Statement of Compliance Access for People with a Disability

263, Queen St, Campbelltown

Report Type: Statement of Compliance - BCA Access Provisions
Development: 263, Queen St, Campbelltown

Levels 9 to 15, - Unit number 0.4

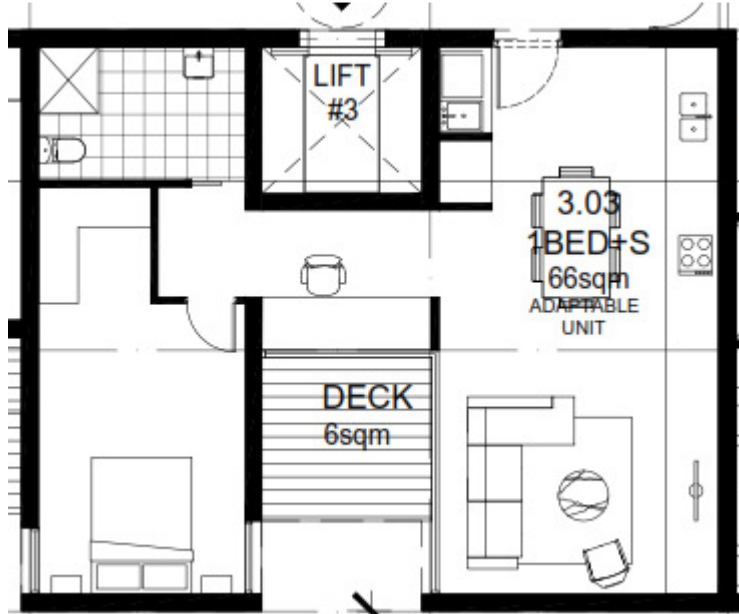
11 adaptable units are required by the Council's DCP. The units designated as adaptable are;

At DA stage there is insufficient information to certify compliance with the Standard, however, in accordance with the table below, the units can comply with the spatial requirements of AS4299 for Adaptable Housing.
